northern
beaches
council

DEVELOPMENT DETERMINATION PANEL MEETING

WEDNESDAY 10 MAY 2023

ITEM 3.1 DA2022/1783 - 49 COLLAROY STREET COLLAROY -
ALTERATIONS AND ADDITIONS TO A DWELLING HOUSE

Figure 1 - Building Height Non-Compliance over garage to balustrade

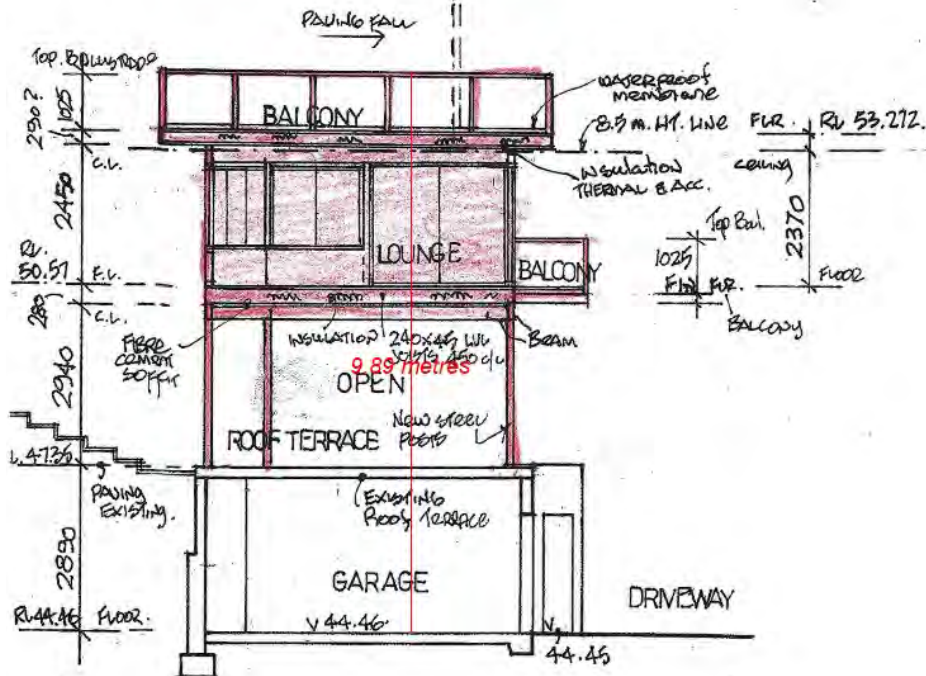
Development standard:	Height of buildings
Requirement:	8.5m
Proposed:	9.89m
Percentage variation to requirement:	16.35%

Figure 2 - Envelope Encroachment along the eastern elevation

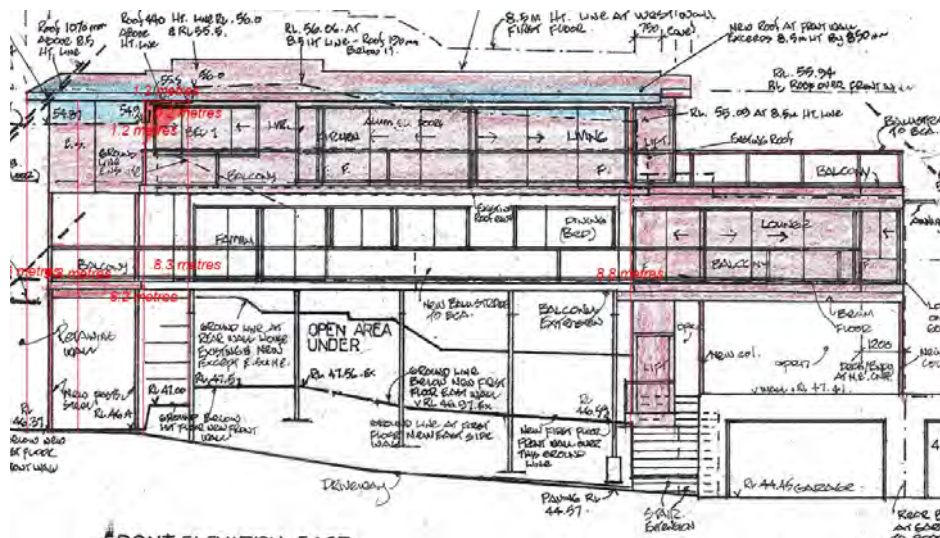
Clause B3 of the DCP requires buildings to be sited within a building envelope determined by projecting places at 45 degrees from 4m above ground level at the side boundaries. The proposed development encroaches into the side boundary envelope along both the eastern and western elevations. As demonstrated in Figure 2 and 3 below, the envelope non-compliance along the eastern elevation occurs along a horizontal length of 1.2m for vertical heights of between 0.2m - 1.2m, whilst the encroachment along the southern elevation occurs along a length of 23.3m over maximum vertical heights of 0.4m - 3.5m.

Figure 1 - Maximum height of building based on the existing ground level RL's. Prepared by Applicant.

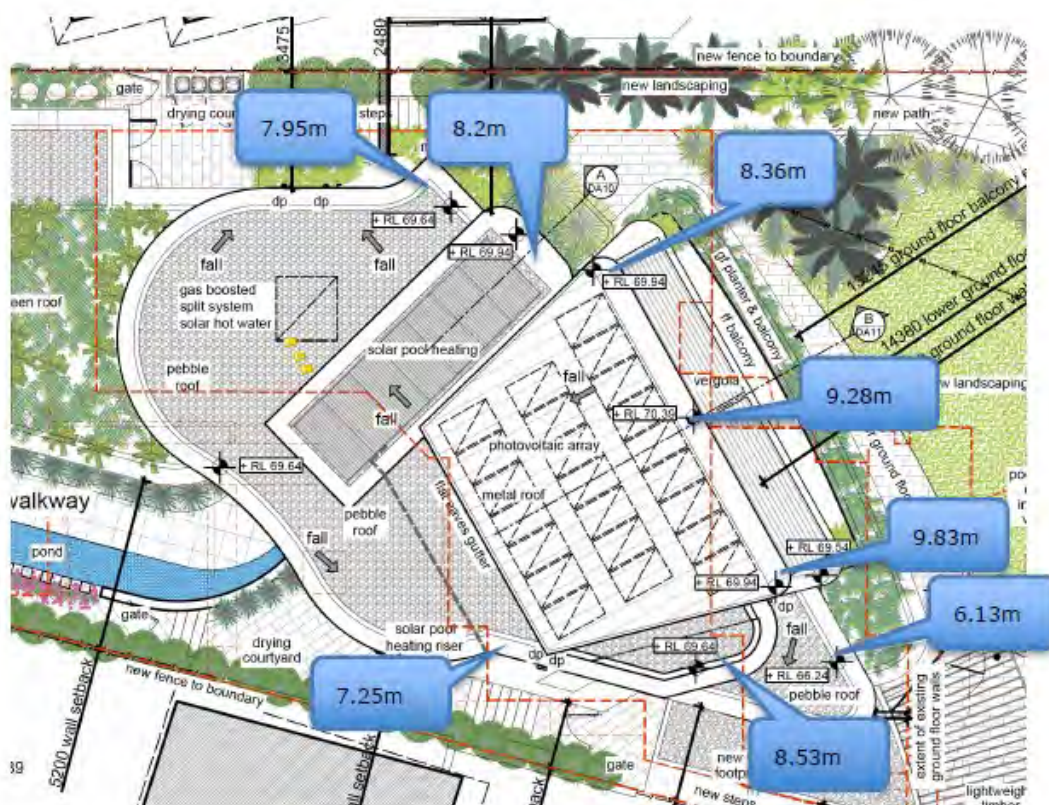
Requirement:	8.5m
Proposed:	9.83m maximum
Percentage variation to requirement:	15.6%

The maximum building height has been assessed taking into consideration the existing ground level RL's beneath the existing house (which is a partially excavated area/subfloor). The highest point of the building (relative to the existing ground level) is 9.83m, which is the top of eastern portion of the roof form at RL69.94 and this is situated over the existing ground level of RL60.11. The applicant has provided a detailed description of the building heights relative to the survey levels within the Clause 4.6 submission. The below figure has also been provided to show the varies heights of the roof above the existing ground level (portions of which sit within an existing excavated portion of the dwelling).

Figure 1 - Western elevation marked up by assessing officer.

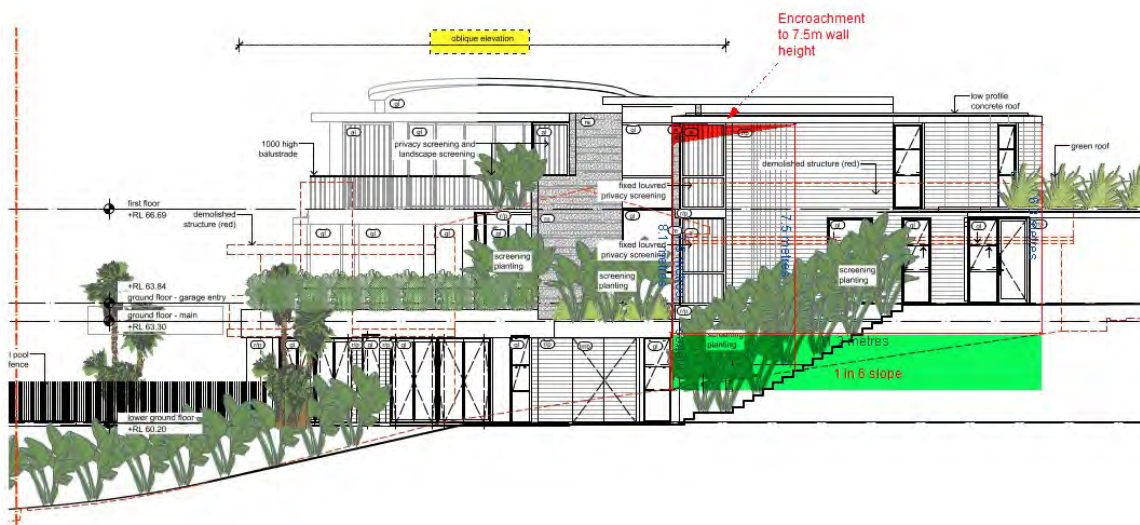
The western elevation has a breach of the maximum wall height for a portion of the building facing the western boundary. The requirement is 7.5m and there is a portion of the western façade up to 8.1m. It is noted that the western elevation shows an oblique elevation which makes the western elevation seem longer than it will be in reality. The area of encroachment is setback between 2.6m and 4.3m and includes a curved wall to provide articulation and softening of this element. The side setback of this portion of the building is compliant. The encroachments to the 8.5m building height located central of the building footprint and result from the curved roof form and is considered in detail in the Clause 4.6 assessment earlier in this report.

33. **Mechanical plant and solar panels on roof**

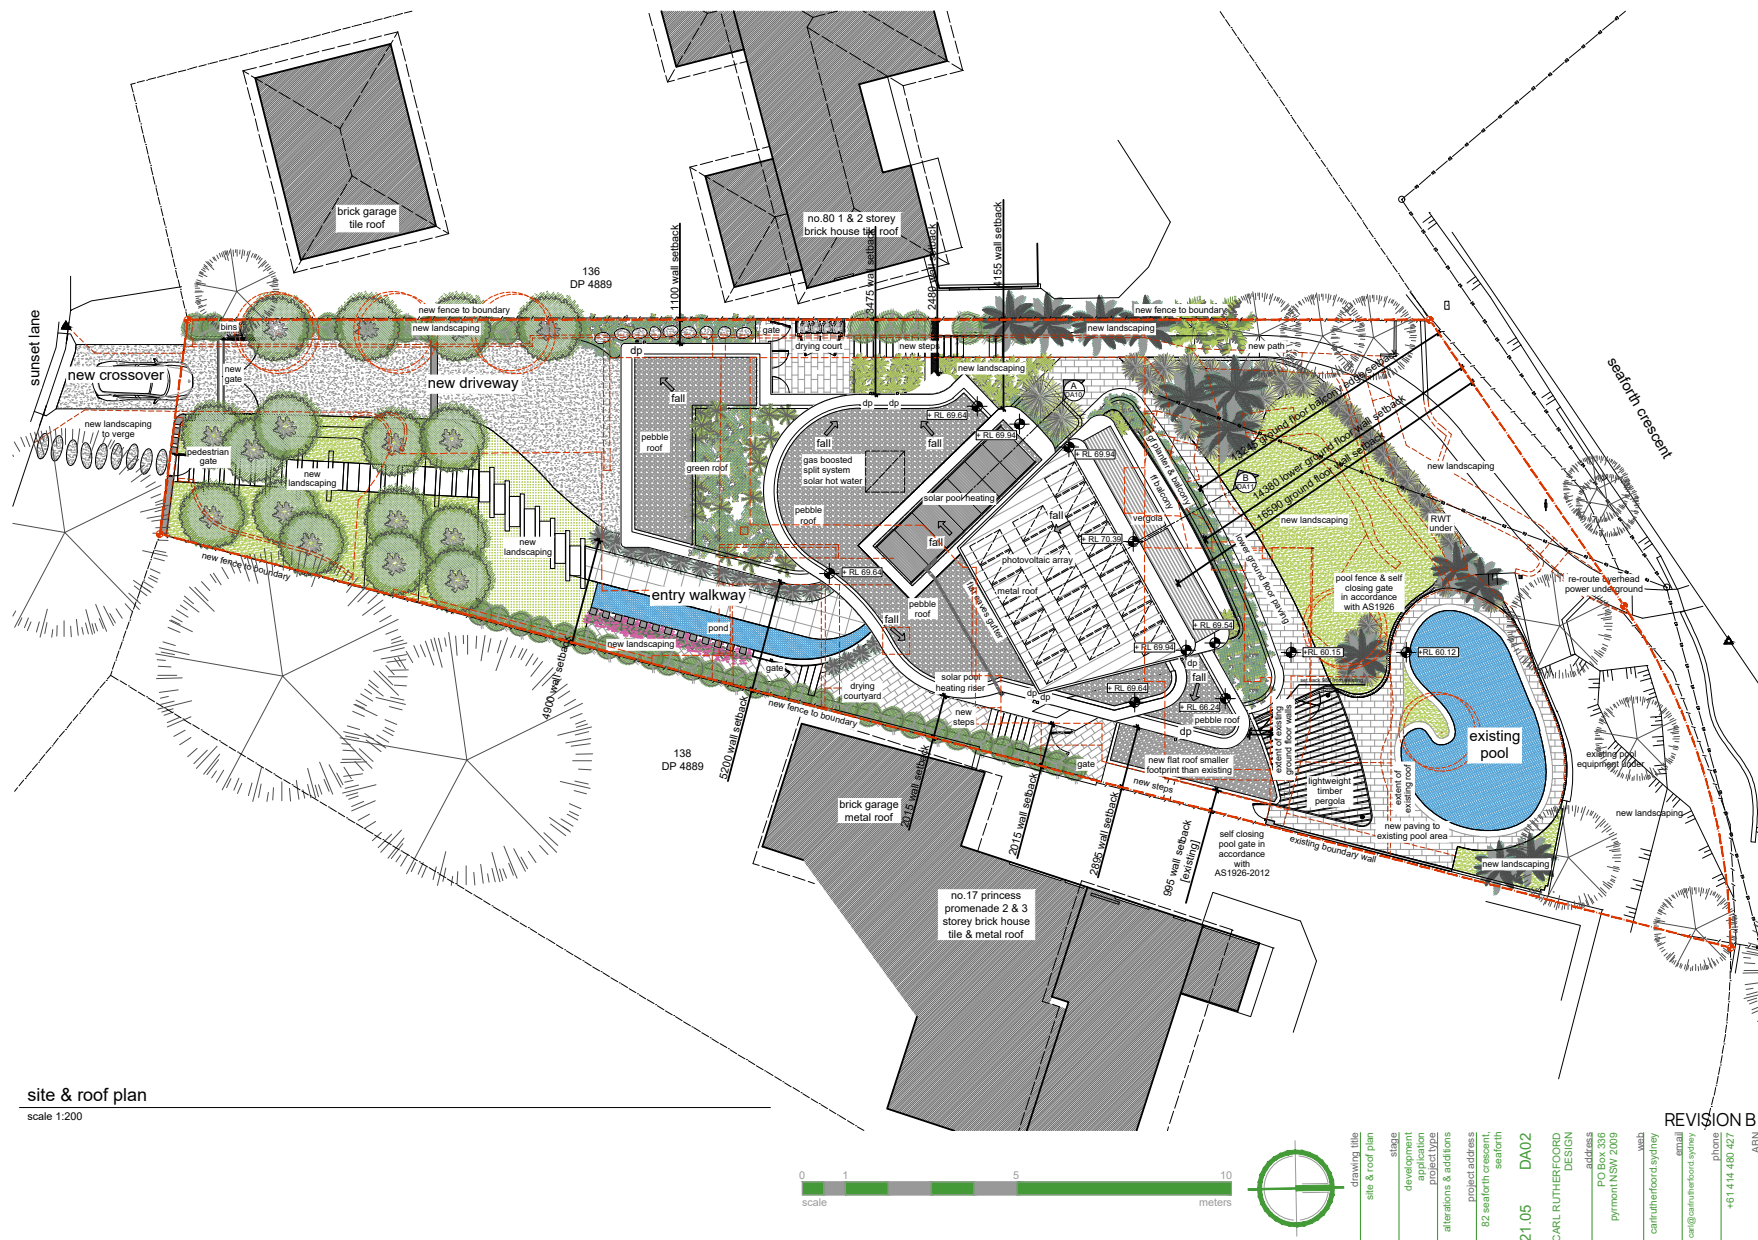
The photovoltaic panels proposed to be located on the central roof shall be mounted flush to the roof surface.

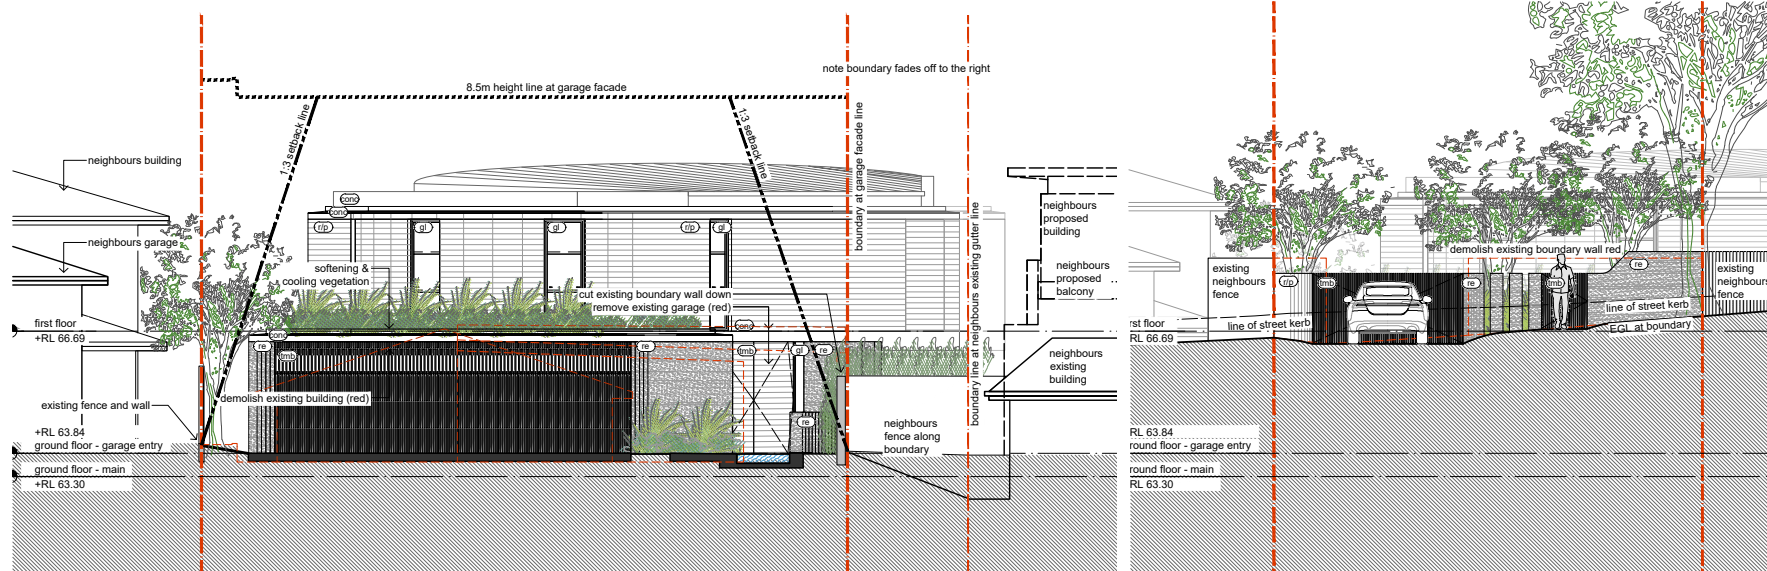
The solar pool heating is to be mounted flush to the roof surface.

The placement of the photovoltaic panels and solar pool heating is to remain as above for the life of the development.

Figure 1- Building Height non-compliance

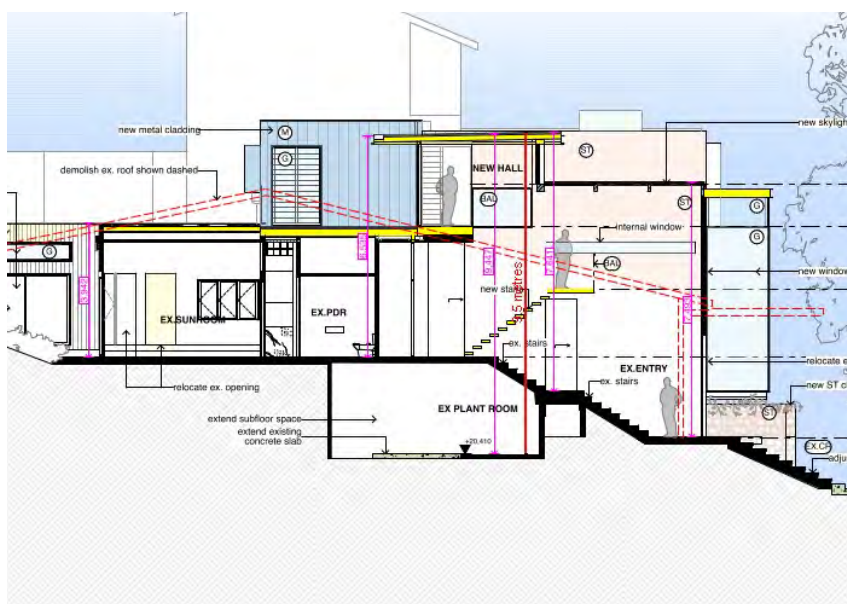
Development standard:	Height of buildings
Requirement:	8.5m
Proposed:	5.85m - 9.47m
Percentage variation to requirement:	11.14% (0.97m)

(Figure 1: Section 1 - Red shading to indicate building height non-compliance)

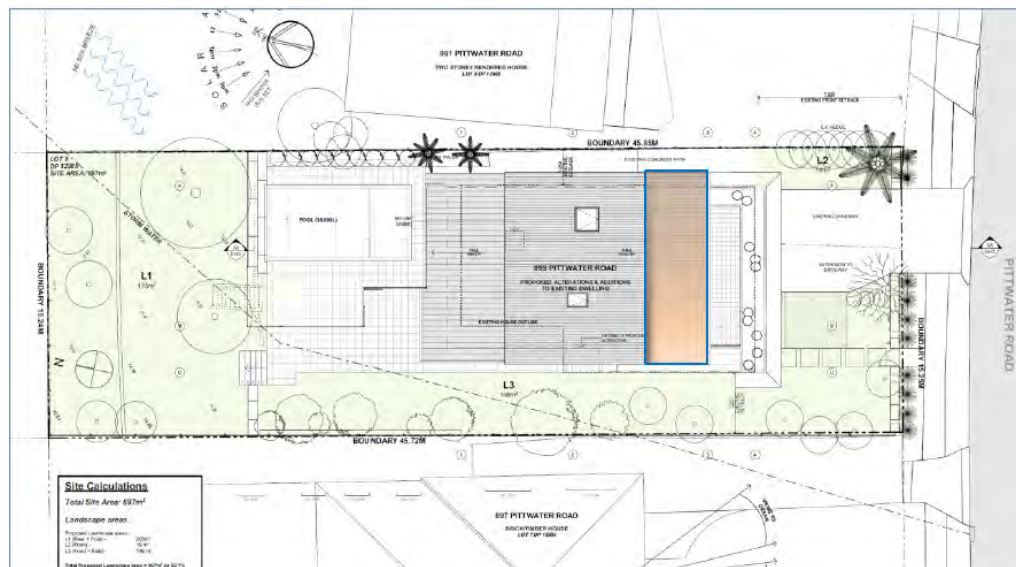
Development standard:	Height of buildings
Requirement:	8.5m
Proposed:	9.85m
Percentage variation to requirement:	15.88%

An extract of the submitted architectural plans and Clause 4.6 Variation demonstrating the extent of non-compliance is shown below:

Figure 4 - (Eastern Elevation - Red shading to demonstrate area of non-compliance)

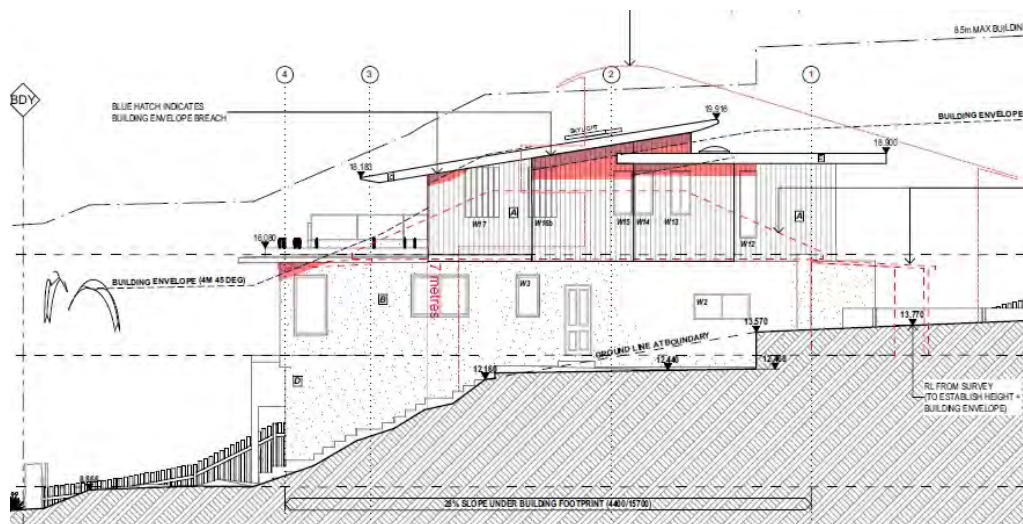
The proposed development encroaches the eastern elevation side boundary envelope, exhibiting a maximum variation of 30.0% (See figure 4 below).

It is recognised that the breach in building envelope is attributed to the pronounced and disjointed topography of the subject site.
